Enclosed for your information is Morrison-Knudsen's (M-K)
response to the Nuclear Regulatory Commission's comments on the
Shiprock Phase II Design Revisions. Please be advised that M-K
has been directed to complete the Remedial Action Plan
Modification incorporating these changes.

Response to NRC Comments of 16 January 1986 on Shiprock Phase II Design Revisions:

Response to NRC Comments on Shiprock Phase II Design Revisions

SHIPROCK PHASE II DESIGN REVISIONS
SURFACE WATER HYDROLOGY AND EROSION PROTECTION
QUESTIONS AND COMMENTS

Proposed No. 5

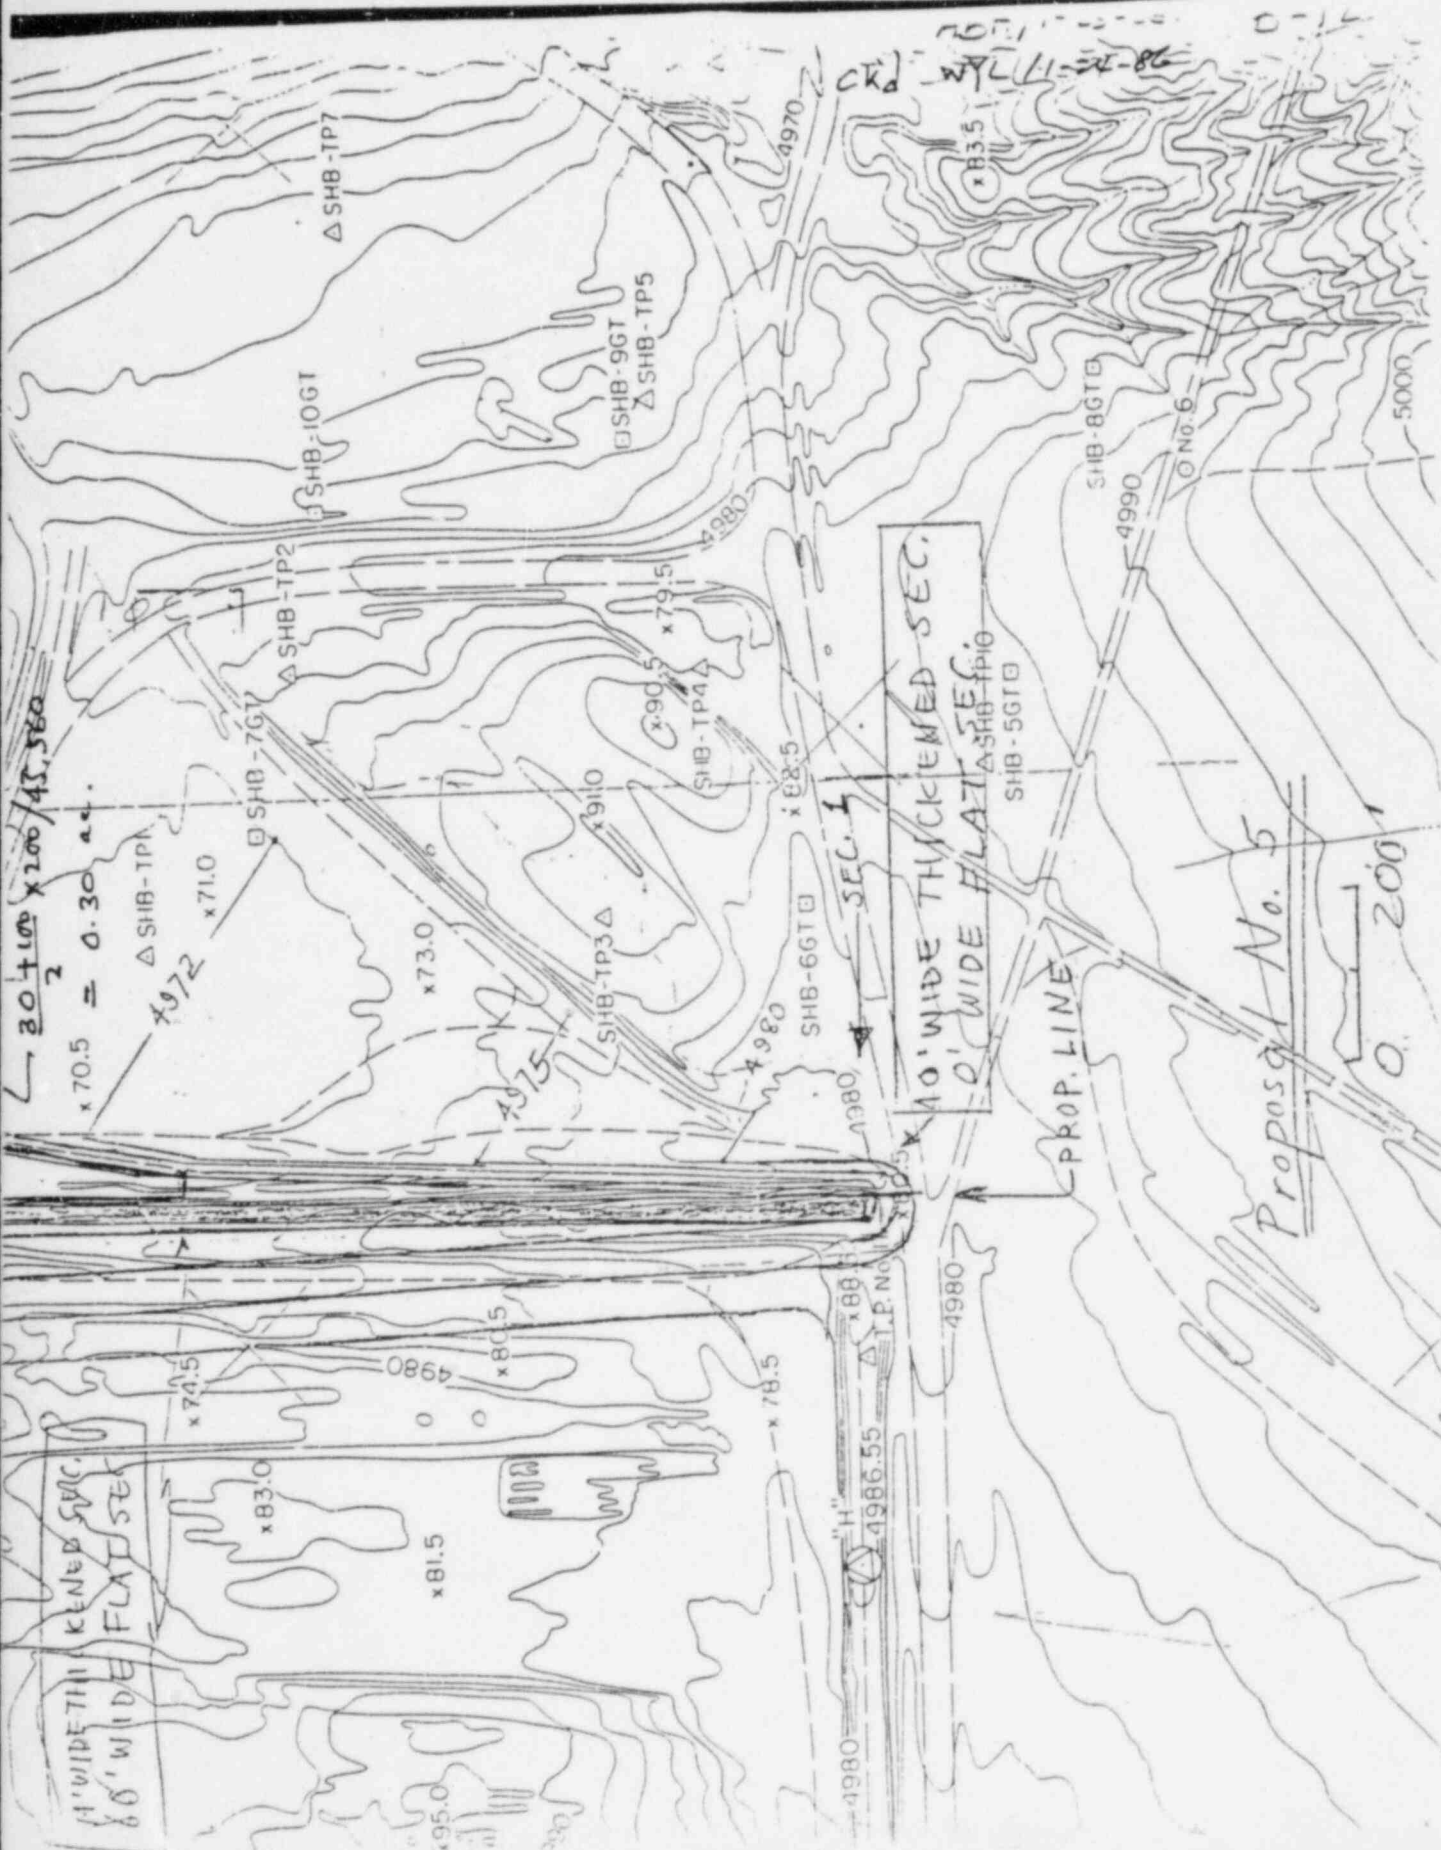
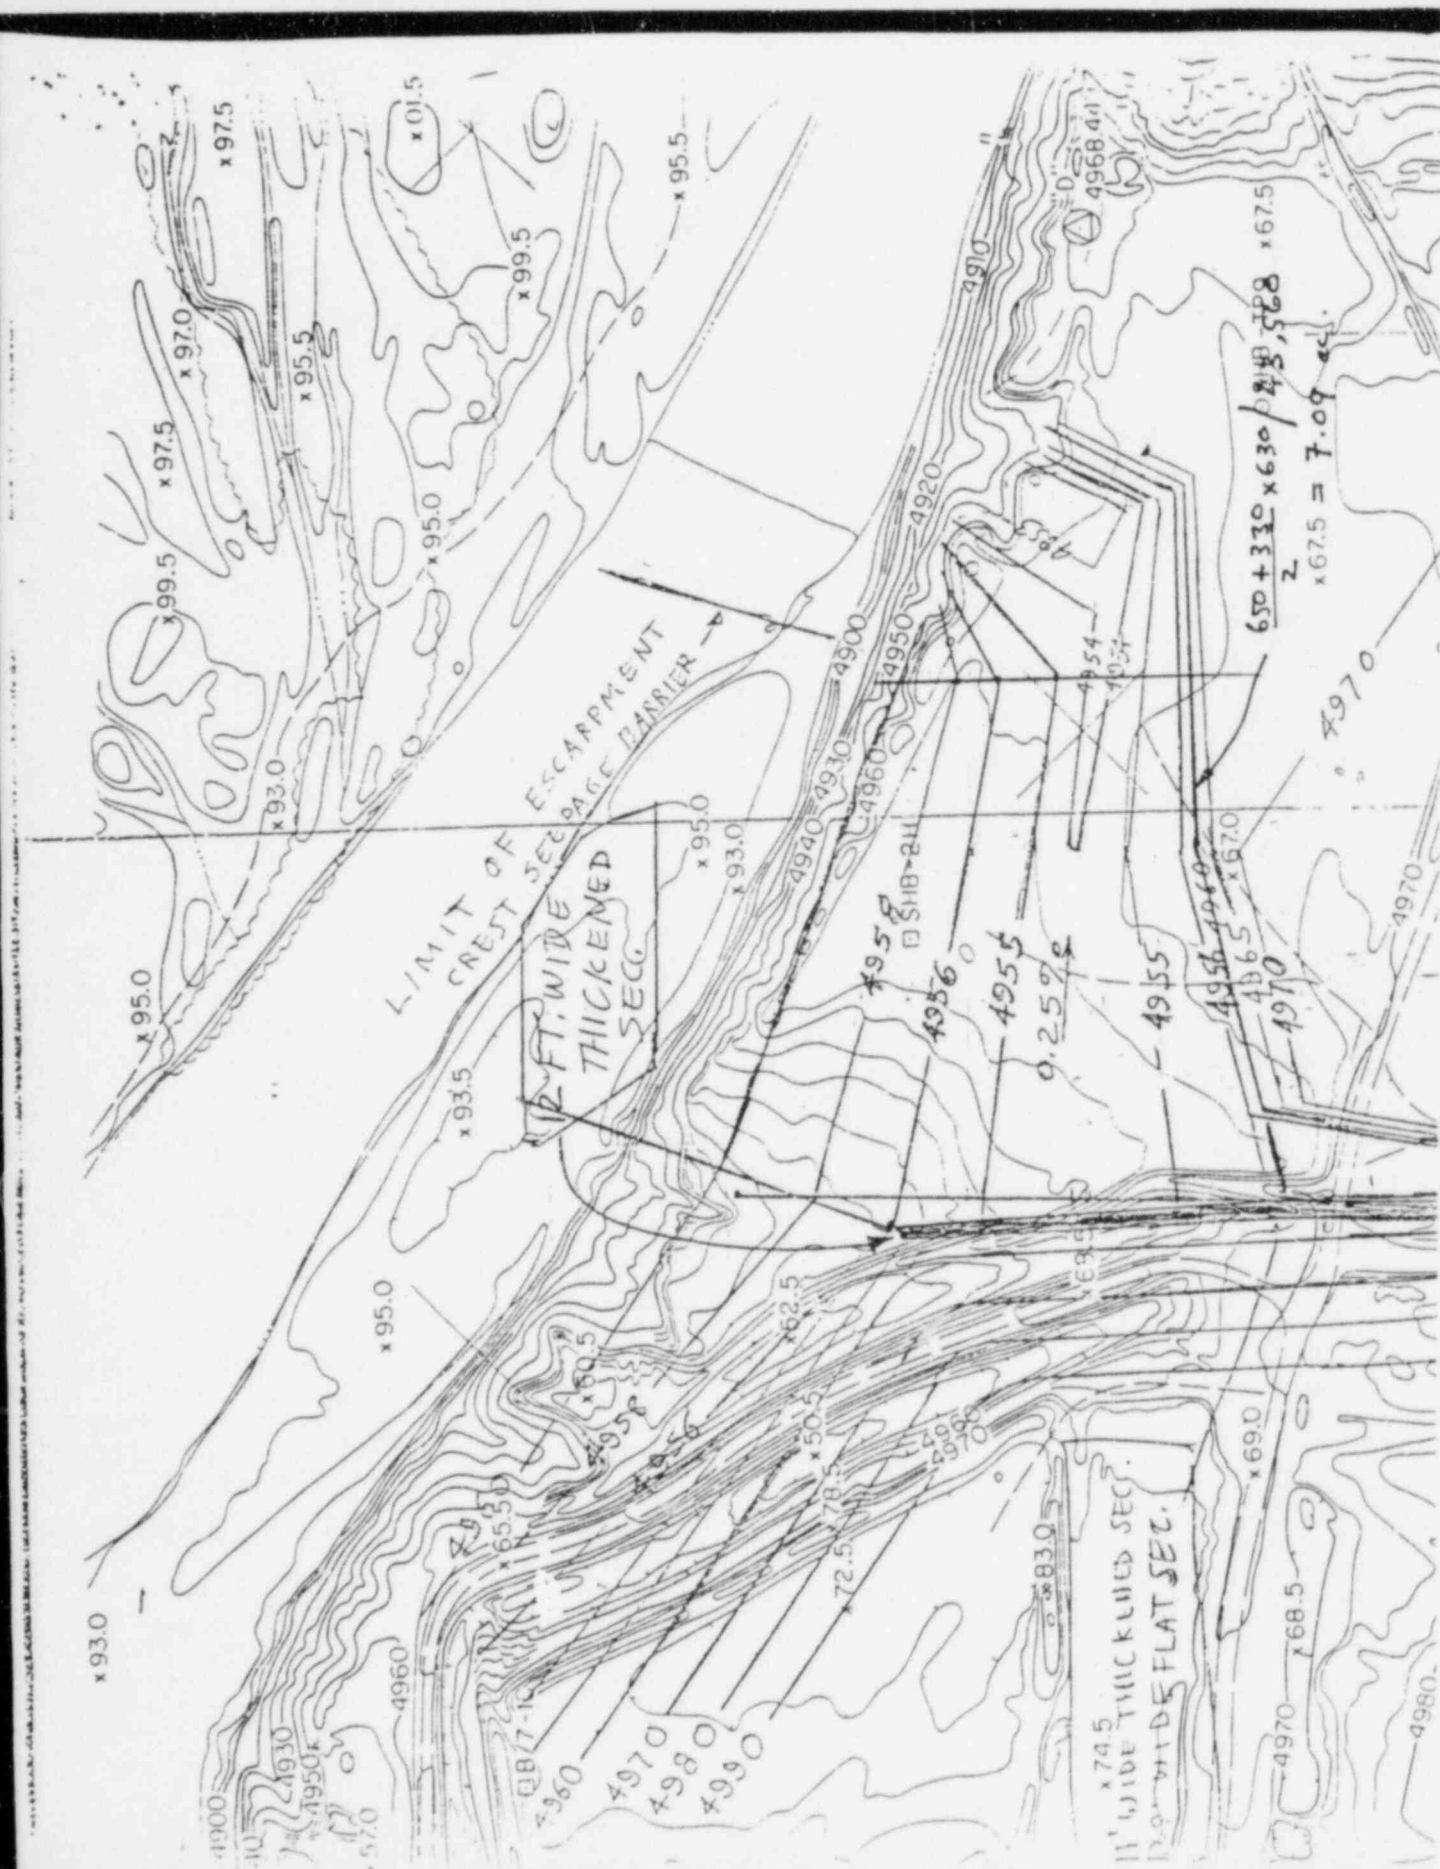
1. Could the PMP flow parallel to the embankment erode the natural material beyond the apron along the SE side of the embankment?
2. Could the PMP overflow from Ditch D-2 erode the natural material beyond the D-2 apron.

1. The grading adjacent to the SE edge of the embankment has been revised and the thickness and width of the apron have been increased to safely transfer the flow beyond the apron away from the embankment at velocities which will not erode the natural materials.
2. The maximum allowable slope beyond the D-2 apron has been set at 10H:1V, which is acceptable for this location.

Widen the apron as follows:

$$= 120 \left(\frac{1.02}{0.75} \right)^{3/2} = 190 \text{ feet.} \leftarrow$$

UNITOR / SHP
Ditch 0-3
Partial Replacement of Ditch 0-3
Figure 2

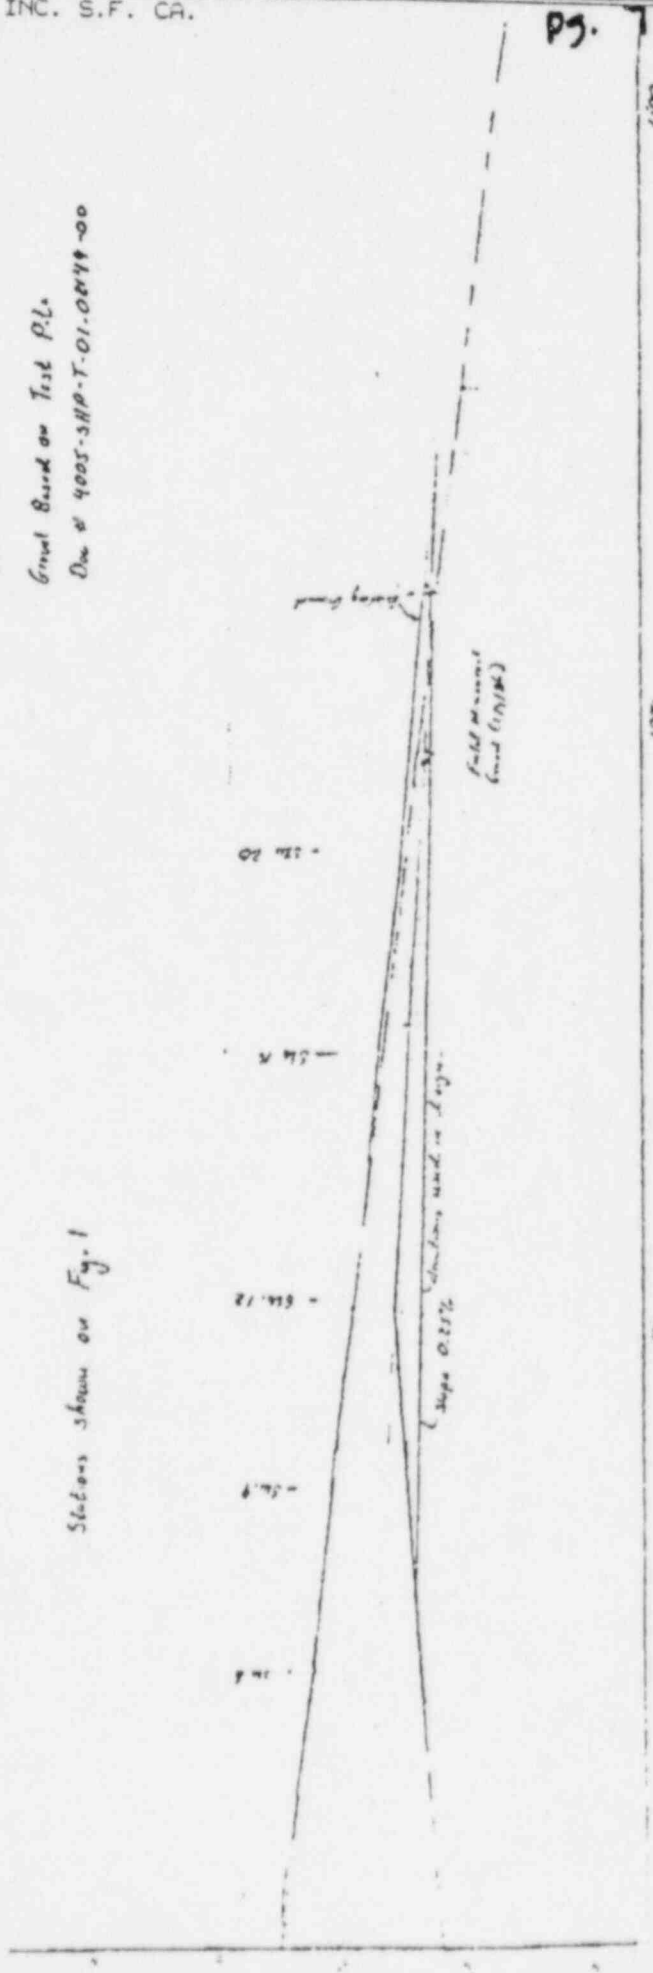
"The elimination of ditches D-3 and D-4 has resulted in a design where runoff is directed over an apron directly over unprotected slopes into the excavated borrow area east of the embankment. While this design concept may be acceptable, it is not immediately evident how erosion of the borrow area slopes will be prevented. Slopes of 5% in silty soils and 10% in gravelly soils (Reference Drawing SHP-PS-10-0022) may not be sufficiently flat to prevent erosion and gullyng of the slopes over long time periods. This is particularly true if concentrated rather than sheet flow occurs on the slopes. Based on the design presented, it appears that concentrated flow could occur, gullies could form, and the gullies could eventually enlarge and headcut toward the protected embankments. In order to resolve this potential erosion problem, the NRC staff suggests that one or more of the following be performed:

A partial length of ditch D-3 is to be replaced to control runoff over the natural silt, until runoff can be released onto natural gravel.

Results: The results from the safety factor program shows that the natural ground has the capability of withstanding the flow from ditch D-3 and the sheet flow from the embankment with a maximum 5% slope.
